PCI-SIG ENGINEERING CHANGE NOTICE

TITLE:	Completion Timeout Control Capability
DATE:	27 April 2005, updated 3 November 2005
AFFECTED DOCUMENT:	PCI Express Base Specification Revision 1.1
SPONSOR:	David Harriman, Intel Corporation

Figure 7-XX: Device Capabilities 2 Register

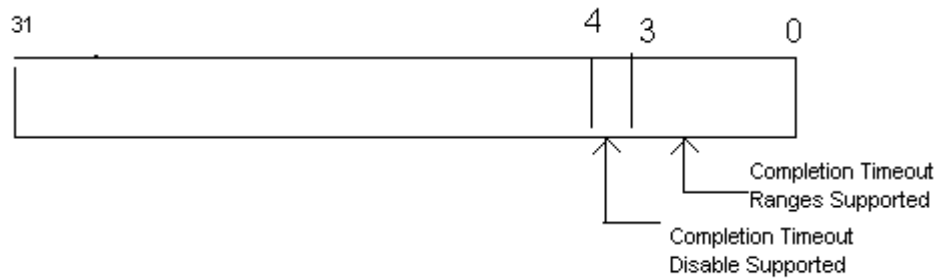
7.8.15 Device Capabilities 2 Register (Offset 24h)

~~This section is a placeholder—There are no capabilities that require this register.~~

Bit Location	Register Description	Attributes
3:0	<p>Completion Timeout Ranges Supported – This field indicates device support for the optional Completion Timeout programmability mechanism. This mechanism allows system software to modify the Completion Timeout value.</p> <p>This field is applicable only to Root Ports, Endpoints that issue requests on their own behalf, and PCI Express to PCI/PCI-X Bridges that take ownership of requests issued on PCI Express. For all other devices this field is reserved and must be hardwired to 0000b.</p> <p>Four time value ranges are defined:</p> <p>_____ Range A: 50us to 10ms</p> <p>_____ Range B: 10ms to 250ms</p> <p>_____ Range C: 250ms to 4s</p> <p>_____ Range D: 4s to 64s</p> <p>Bits are set according to the table below to show timeout value ranges supported.</p> <p>_____0000b _____ Completion Timeout programming not supported – the device must implement a timeout value in the range 50us to 50ms.</p> <p>_____0001b _____ Range A</p> <p>_____0010b _____ Range B</p> <p>_____0011b _____ Ranges A & B</p> <p>_____0110b _____ Ranges B & C</p> <p>_____0111b _____ Ranges A, B & C</p> <p>_____1110b _____ Ranges B, C & D</p> <p>_____1111b _____ Ranges A, B, C & D</p> <p>All other values are reserved.</p> <p>It is strongly recommended that the Completion Timeout mechanism not expire in less than 10ms</p>	HwInit

Bit Location	Register Description	Attributes
4	<p>Completion Timeout Disable Supported – A value of 1b indicates support for the Completion Timeout Disable mechanism.</p> <p>The Completion Timeout Disable mechanism is required for Endpoints that issue requests on their own behalf and PCI Express to PCI/PCI-X Bridges that take ownership of requests issued on PCI Express.</p> <p>This mechanism is optional for Root Ports.</p> <p>For all other devices this field is reserved and must be hardwired to 0b.</p>	RO

Figure 7-XX: Device Control 2 Register

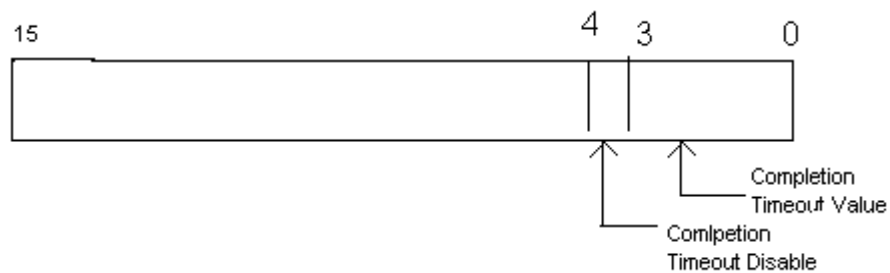
7.8.16 Device Control 2 Register (Offset 28h)

Bit Location	Register Description	Attributes
3:0	<p>Completion Timeout Value – In Devices that support Completion Timeout programmability, this field allows system software to modify the Completion Timeout value. This field is applicable to Root Ports, Endpoints that issue requests on their own behalf, and PCI Express to PCI/PCI-X Bridges that take ownership of requests issued on PCI Express. For all other devices this field is reserved and must be hardwired to 0000b.</p> <p>A Device that does not support this optional capability must hardwire this field to 0000b and is required to implement a timeout value in the range 50us to 50ms. Devices that support Completion Timeout programmability must support the values given below corresponding to the programmability ranges indicated in the Completion Timeout Values Supported field.</p> <p>Defined encodings:</p> <p><u>0000b</u> Default range: 50us to 50ms</p> <p>It is strongly recommended that the Completion Timeout mechanism not expire in less than 10ms</p> <p>Values available if Range A (50us to 10ms) programmability range is supported:</p> <p><u>0001b</u> 50us to 100us <u>0010b</u> 1ms to 10ms</p> <p>Values available if Range B (10ms to 250ms) programmability range is supported:</p> <p><u>0101b</u> 16ms to 55ms <u>0110b</u> 65ms to 210ms</p> <p>Values available if Range C (250ms to 4s) programmability range is supported:</p> <p><u>1001b</u> 260ms to 900ms <u>1010b</u> 1s to 3.5s</p> <p>Values available if the Range D (4s to 64s) programmability range is supported:</p> <p><u>1101b</u> 4s to 13s <u>1110b</u> 17s to 64s</p> <p>Values not defined above are Reserved.</p> <p>Software is permitted to change the value in this field at any time. For requests already pending when the Completion Timeout Value is changed, hardware is permitted to use either the new or the old value for the outstanding requests, and is permitted to base the start time for each request either on when this value was changed or on when each request was issued.</p> <p>The default value for this field is 0000b.</p>	RW

Bit Location	Register Description	Attributes
4	<p>Completion Timeout Disable – When set to 1b, this bit disables the Completion Timeout mechanism.</p> <p>This field is required for all devices that support the Completion Timeout Disable Capability.</p> <p>Software is permitted to set or clear this bit at any time. When set, the Completion Timeout detection mechanism is disabled. If there are outstanding requests when the bit is cleared, it is permitted but not required for hardware to apply the completion timeout mechanism to the outstanding requests. If this is done, it is permitted to base the start time for each request on either the time this bit was cleared or the time each request was issued.</p> <p>The default value for this bit is 0b.</p>	RW
